Attachment

Supplement to March 1, 1984
Proposed Administrative Technical
Specification Change

Proposed Changed Pages

Figure 6.2-2 Facility Organization

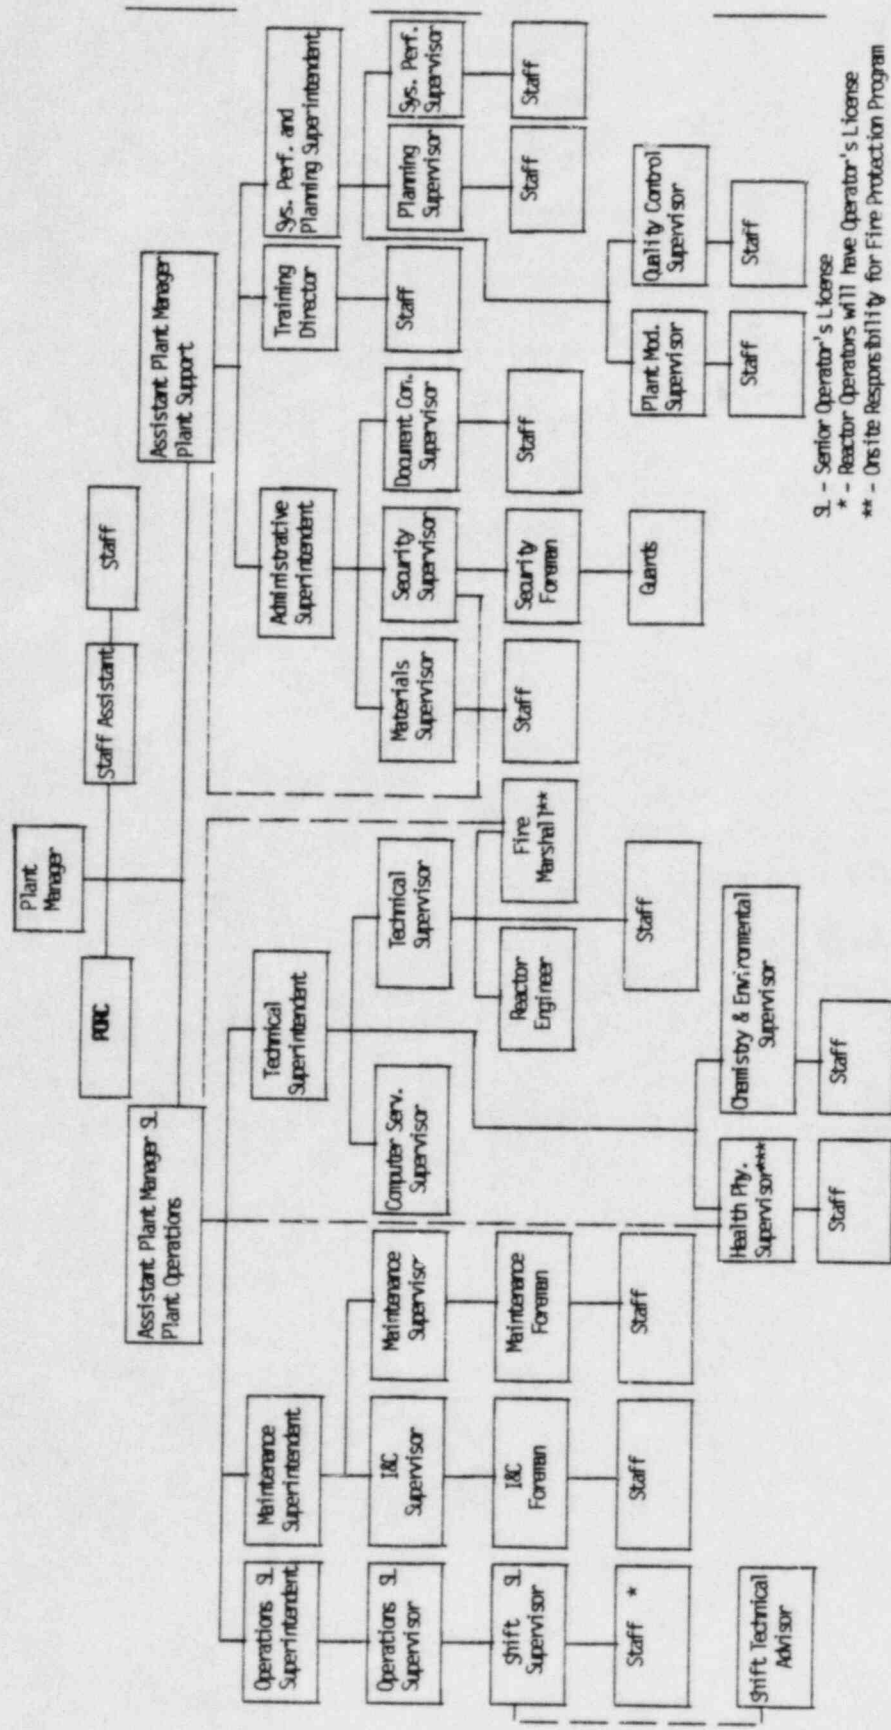
*** In routine matters, the Health Physics Supervisor reports directly to the Technical Superintendent, in matters of radiation policy determination, interpretation or implementation (Based upon the Health Physics Supervisor's judgment) the Health Physics Supervisor may report directly to the Assistant Plant Manager.

Figure 6.2-2 Facility Organization

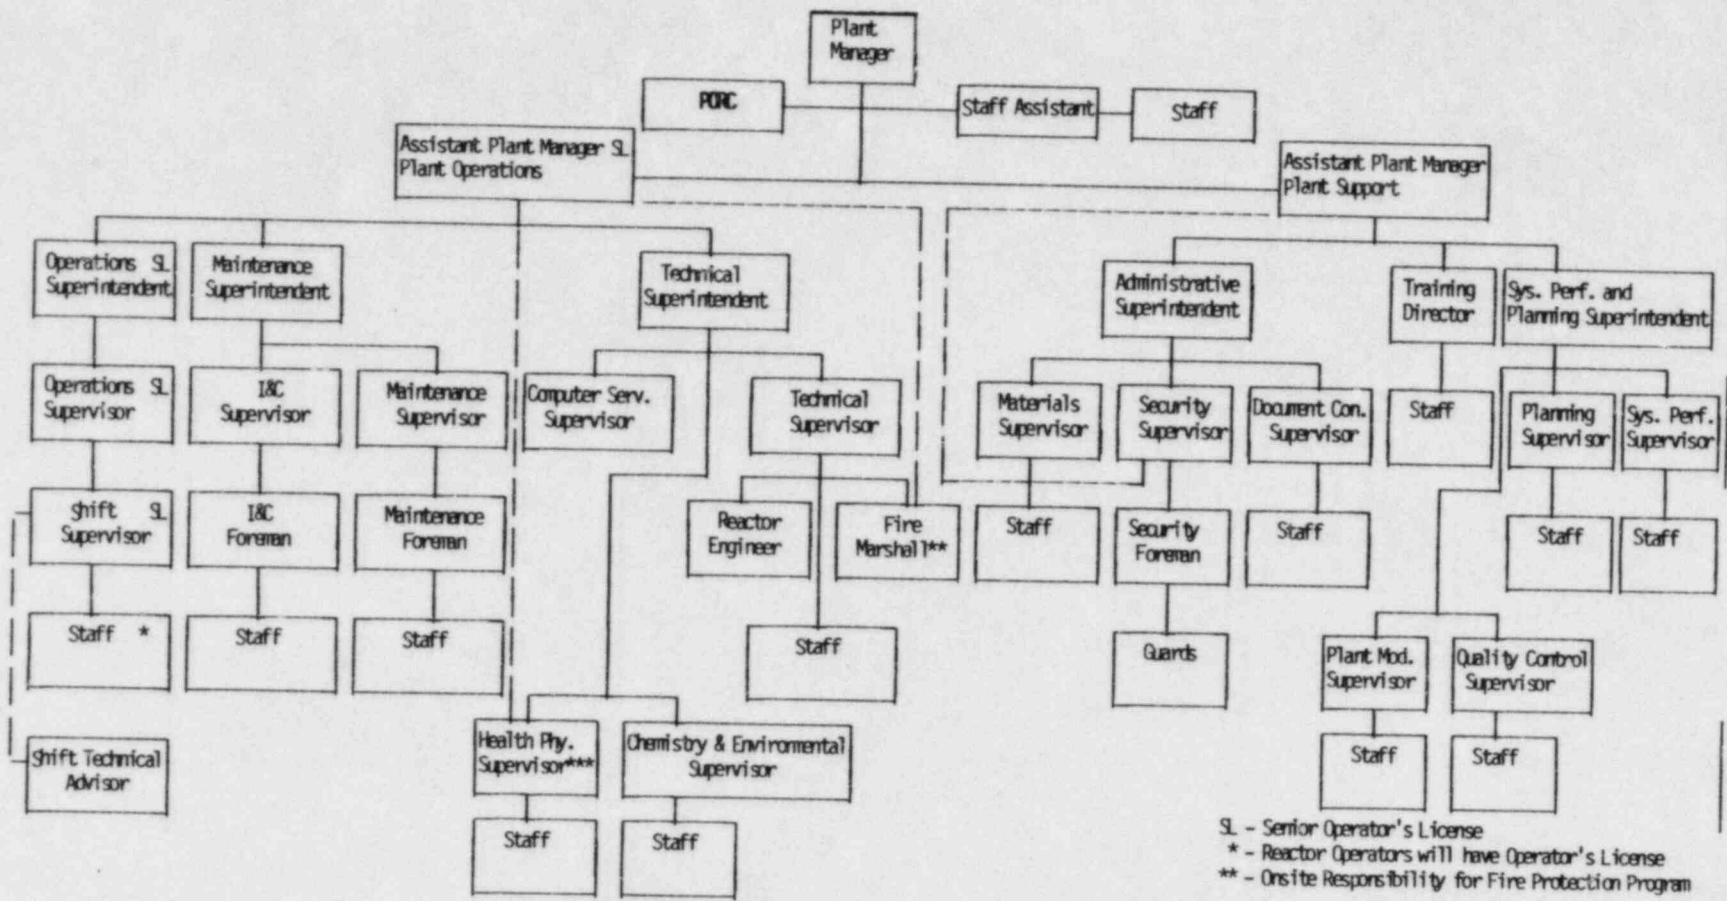
*** In routine matters, the Health Physics Supervisor reports directly to the Technical Superintendent, in matters of radiation policy determination, interpretation or implementation (Based upon the Health Physics Supervisor's judgment) the Health Physics Supervisor may report directly to the Assistant Plant Manager.
